Service Bulletin

Bulletin No.: 25-NA-015

Subject: Information on Accessory Rocker Panel Molding Ground Lamp Package Incorrect Terminal

Brand:	Model:	Model Year:		Build Date:		Engine:	Transmission:
		from	to	from	to		
Cadillac	Escalade IQ	2025	2025

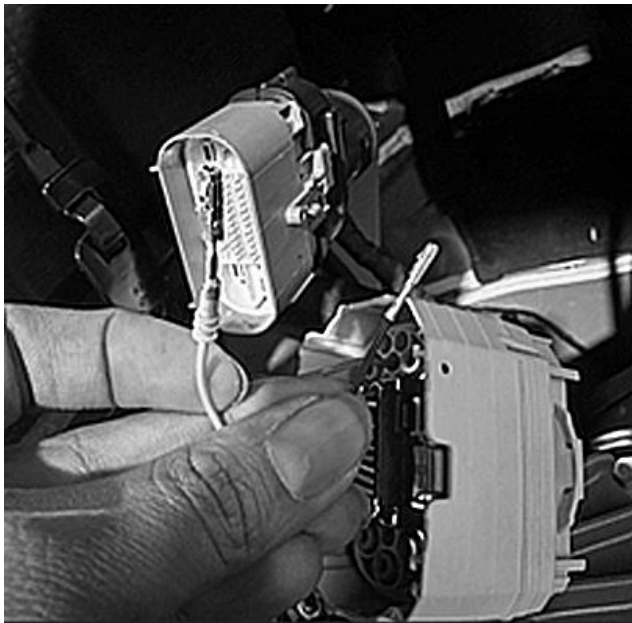
Involved Region or Country	North America
Condition	 <p data-bbox="1420 1444 1492 1467">6819489</p> <p data-bbox="526 1467 1189 1489">Note: Black wire removed from electrical connector for clarity.</p> <p data-bbox="526 1496 1476 1568">During installation of the accessory rocker panel molding ground lamp package, the included accessory harness for the passenger side may have a terminal that is double in size vs. the terminal taken out of cavity 12 of engine harness connector X111.</p> <ul data-bbox="526 1579 1476 1624" style="list-style-type: none"> - Gray wire with larger incorrect terminal included in accessory wire harness. Black wire from vehicle X111, cavity 12.

Cause	Incorrect oversized terminal installed on the passenger side accessory wire harness on the gray wire.
Correction	<ol style="list-style-type: none"> 1. Cut off the larger terminal from the gray wire on accessory harness. 2. Leave the black wire and terminal in cavity 12 of the X111 electrical connector. 3. Cut the black wire approximately 1 inch from the electrical connector and apply Woven Polyester Electrical Tape (PET) to cover over end of the terminal side wire. 4. Using an appropriate gauge dura-seal butt splice, connect the gray accessory side and black harness side wire together. 5. Secure the wire with PET tape. 6. Verify the operation of the rocker molding lamps.
